SUBJECT: LaSalle County Nuclear Power Station Units 1 and 2
Supplement to August 28, 1995 Request for Application for
Amendment to Facility Operating Licenses NPF-11 and NPF-18,
Appendix A, Technical Specifications, and Exemption to Appendix J
of 10CFR50 Regarding Elimination of MSIV Leakage Control System
and Increased MSIV Leakage Limits
NRC Docket Nos. 50-373 and 50-374

RESPONSE TO NRC QUESTIONS

MAINSTEAM ISOLATION VALVE-ALTERNATE LEAKAGE TREATMENT SYSTEM

LASALLE UNITS 1 & 2

EXHIBIT 18

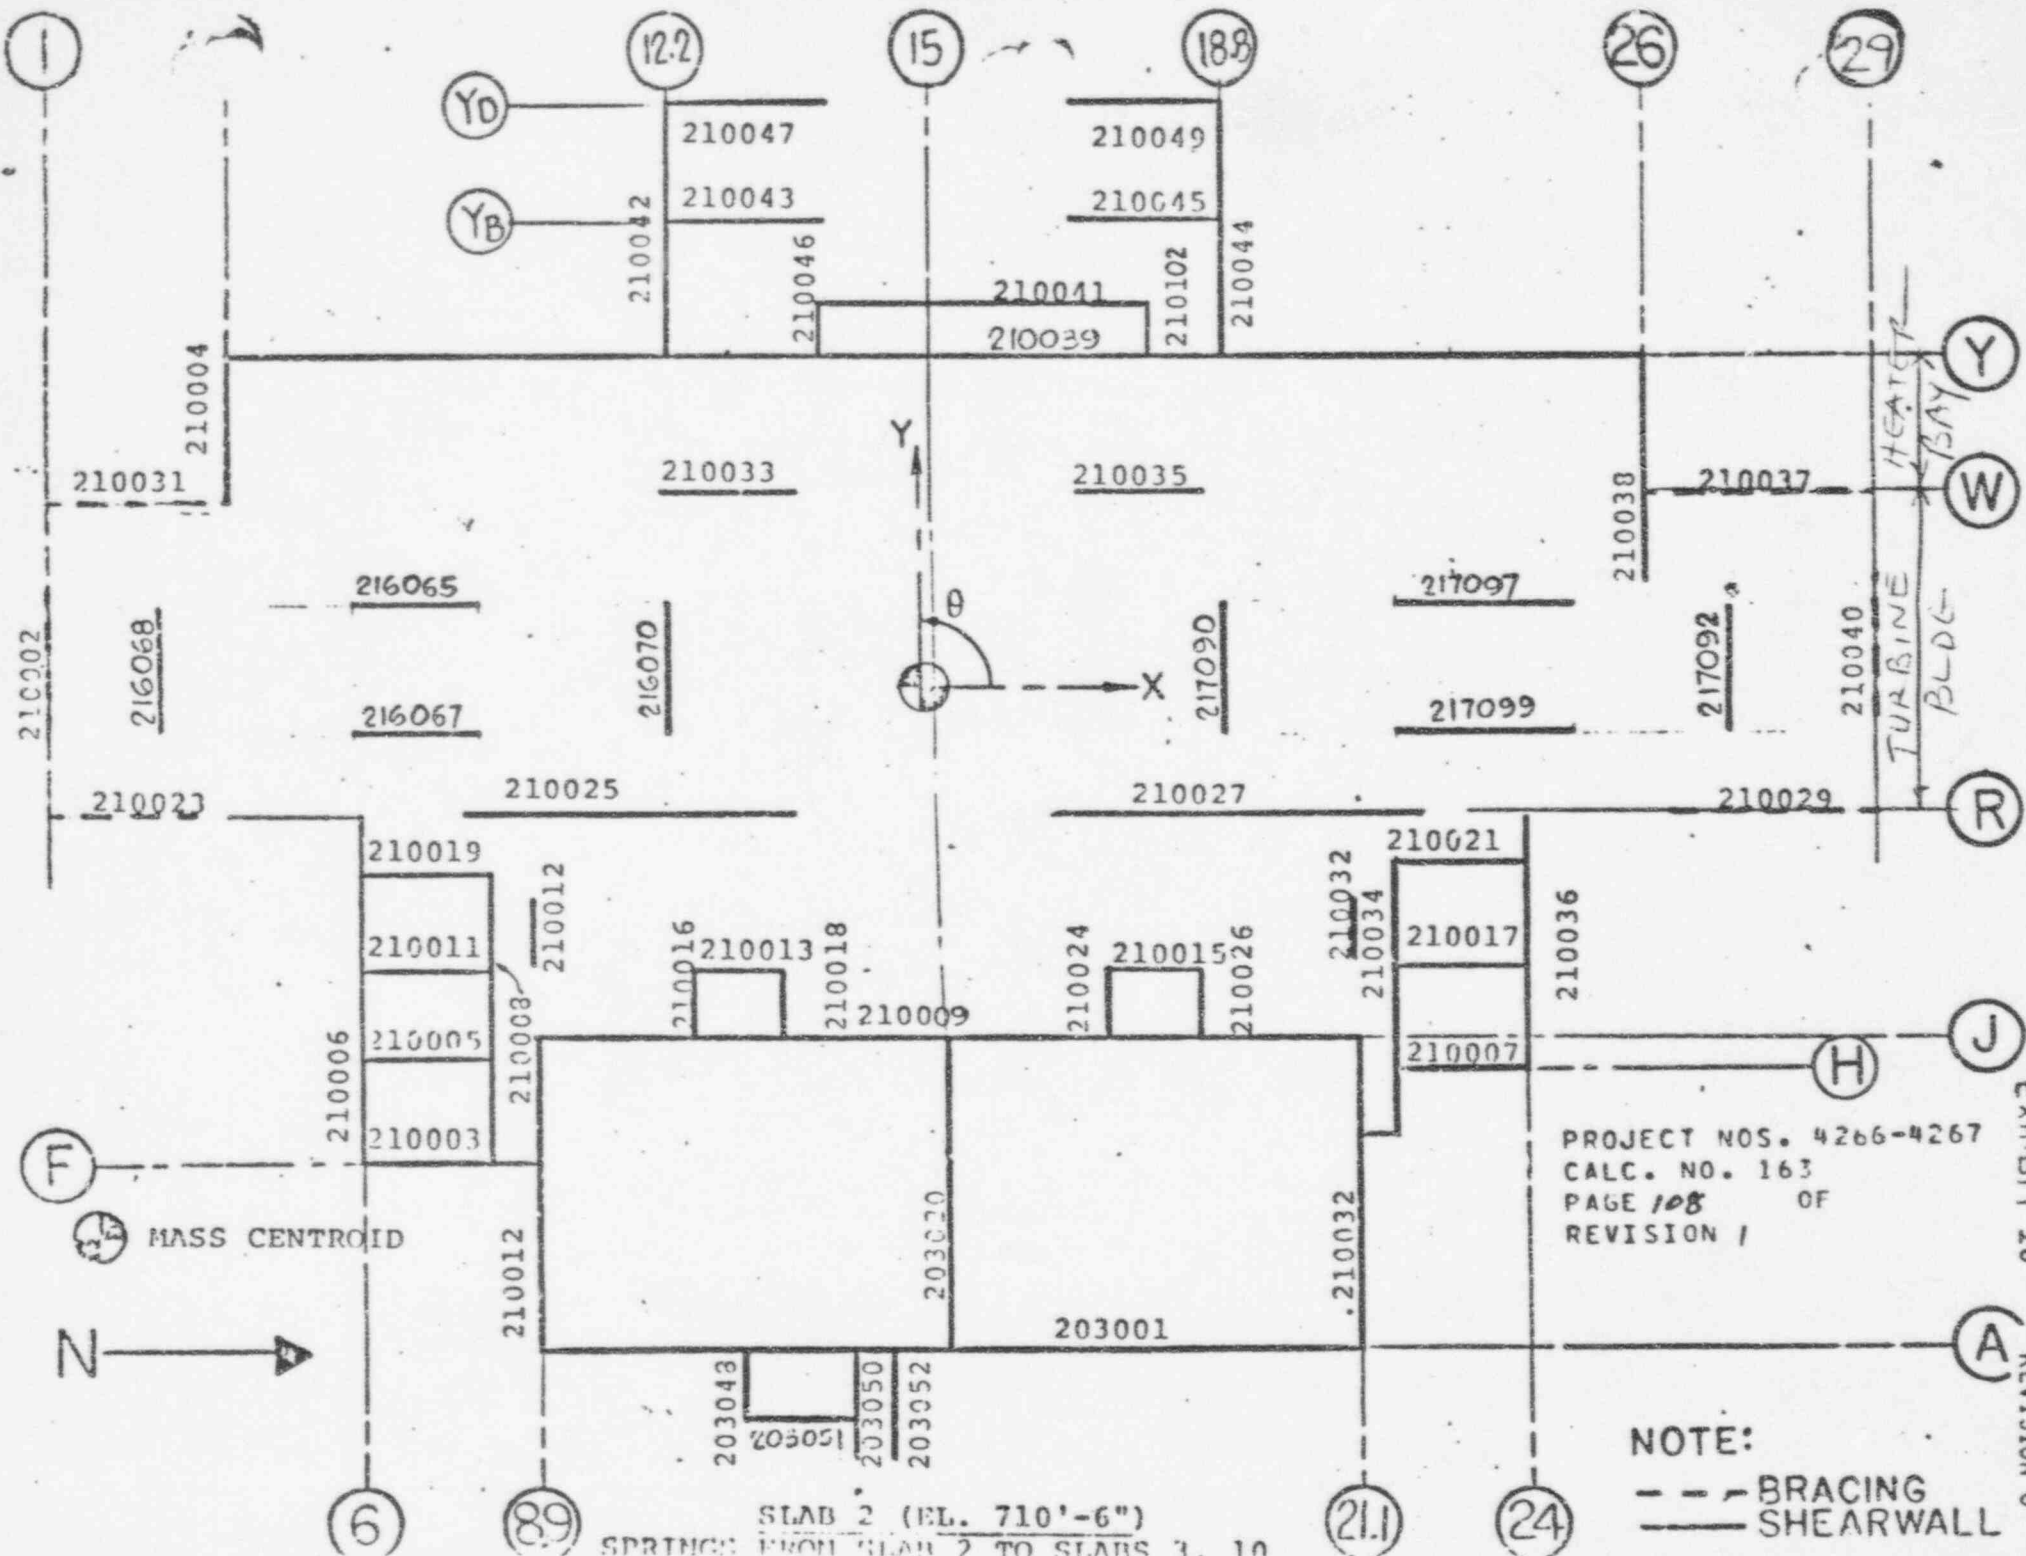
the following Exhibits from this design criteria book which show the layout of various shear walls and braced bays with their specific spring numbers, as included in the seismic model of various building structures for LaSalle County Station.

- Exhibit 18 : Slab 2 (El. 710'-6"), springs from Slab 2 to slabs 3 and 10.
- Exhibit 19 : Slab 10 (EL. 731'-0"), springs from slab 10 to slabs 3, 11, 13, 14, 18.
- Exhibit 25 : Slab 14 (El. 768'-0"), springs from slab 14 to slabs 5, 6, 8.
- Exhibit 31 : Vertical seismic model of Turbine Heater Bay and Radwaste Buildings.
